**Subject: Response to Environmental Questions Regarding Materials License
No. SNM-33 Renewal Application**

**COMBUSTION ENGINEERING, INC. RESPONSE TO
NRC COMMENTS ON THE HEMATITE RENEWAL APPLICATION
DATED NOVEMBER 22, 1989**

**COMBUSTION ENGINEERING, INC. RESPONSE TO
NRC REQUEST FOR ADDITIONAL INFORMATION ON
HEMATITE RENEWAL APPLICATION DATED NOVEMBER 22, 1989**

**COMBUSTION ENGINEERING, INC.
REVISED PAGES IN RESPONSE TO NRC REQUEST
FOR ADDITIONAL INFORMATION ON HEMATITE RENEWAL APPLICATION
DATED NOVEMBER 22, 1989**

FIGURE 1: POPULATION FOR MISSOURI COUNTIES WITHIN A 50 MILE RADIUS FROM THE HEMATITE FACILITY

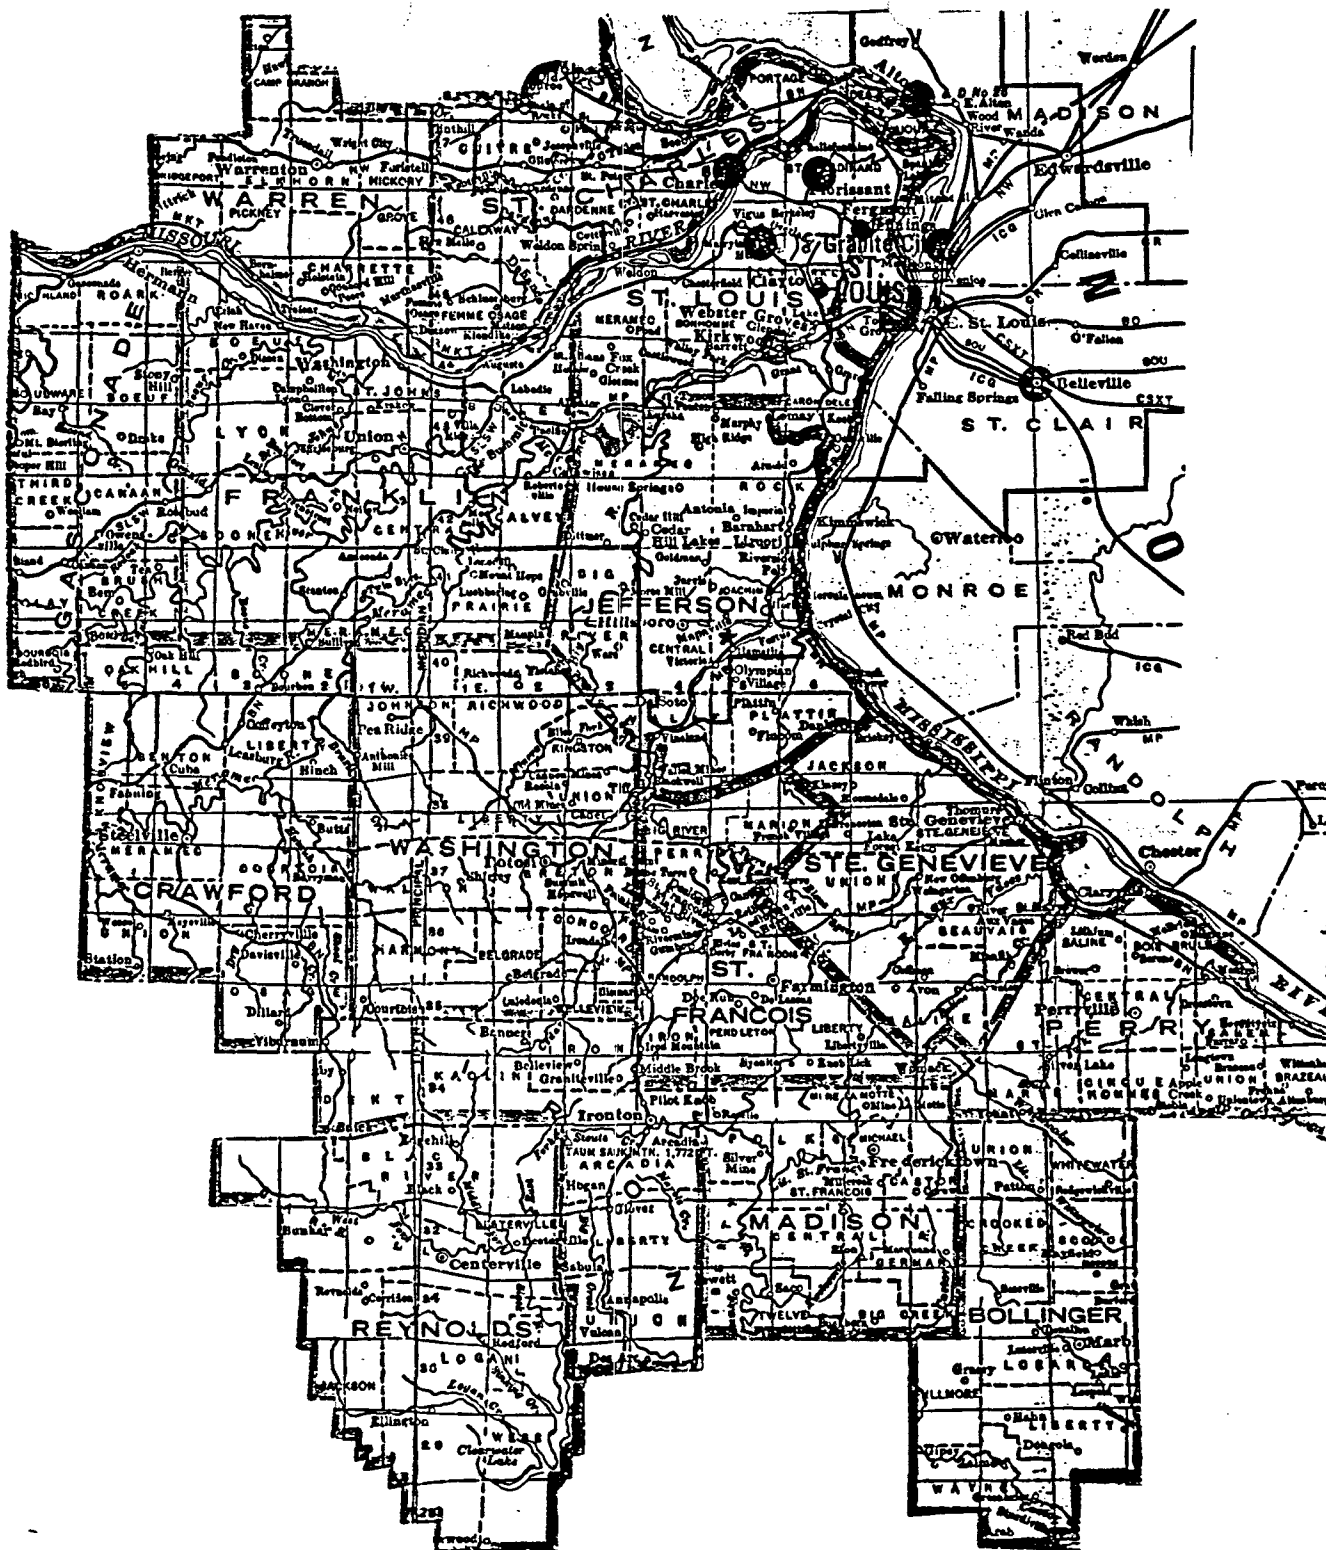
5. Table 1 provides average meteorology of site.
6. The population estimates for areas within a 50 mile radius of the Hematite Facility are identified on Figures 1 & 2. This information was obtained from Missouri Economic Development Department and the University of Missouri.
7. Provided in October 11, 1991 response.
8. Provided in October 11, 1991 response.
9. Dose calculations to demonstrate compliance with 40 CFR 190.10 for 1984 through 1990.

FIGURE 3. EXHAUST STACK LOCATIONS AND HEIGHTS

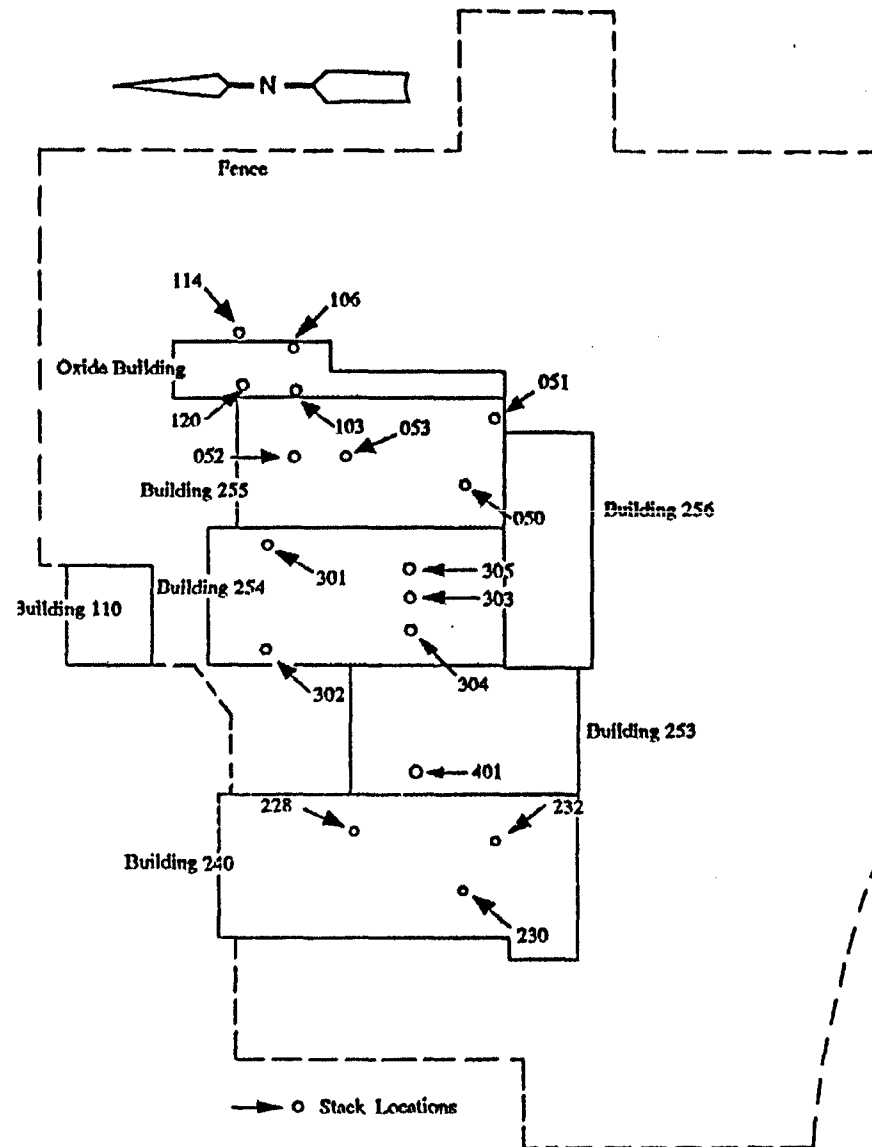
10. The height of the plant stacks is shown on Figure 3. Stacks are in operation essentially 100% of the time.
11. The nearest resident to the Hematite site is 290 meters east-southeast of the site boundary.
12. Yes, near iso-kinetic sampling is conducted for measuring stack effluents.

FIGURE 13-1. LOCATIONS OF AIR MONITORING SITES

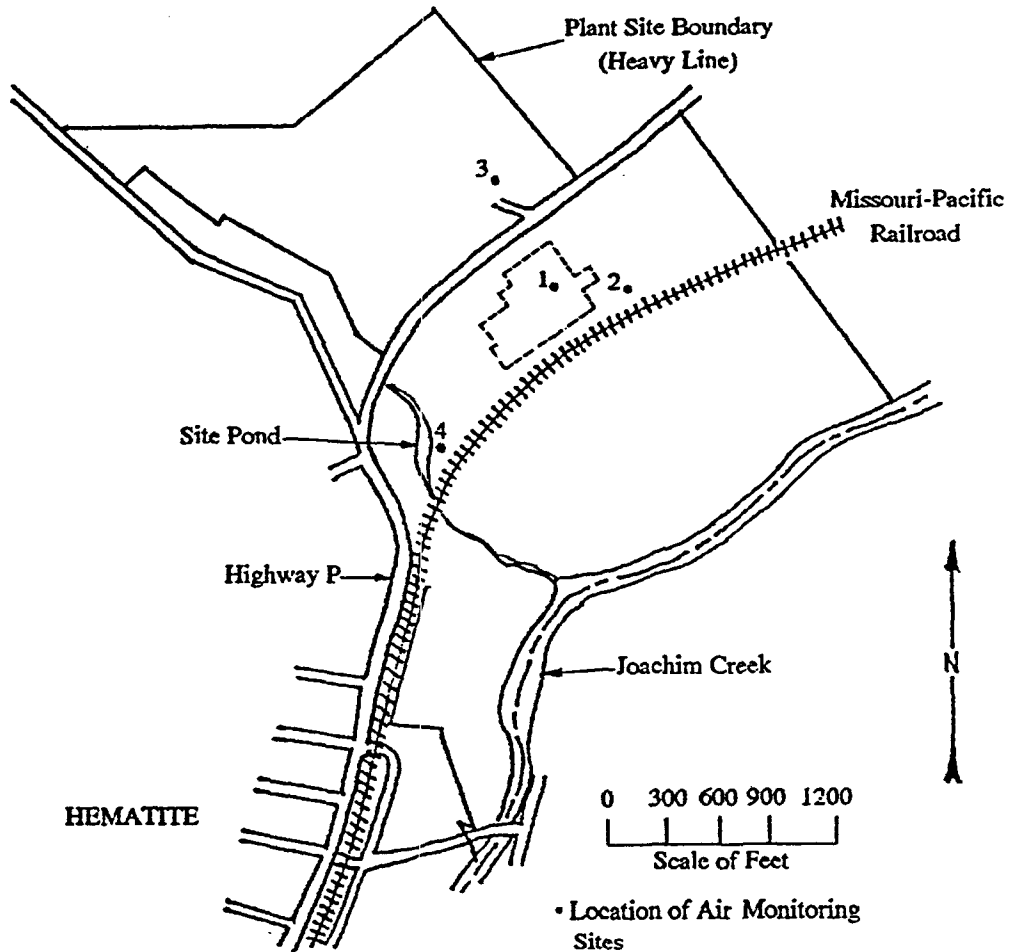
Table 5-1 has been expanded to include a reference to the applicable data table in Chapter 13. This has been included for information only, and should not make the Chapter 13 information conditions of the license. Also, the sample location map from Chapter 13 has been divided into three (3) separate figures to more clearly depict sample types and locations. Each figure

includes a table to correlate sample location with the appropriate Data Table(s).
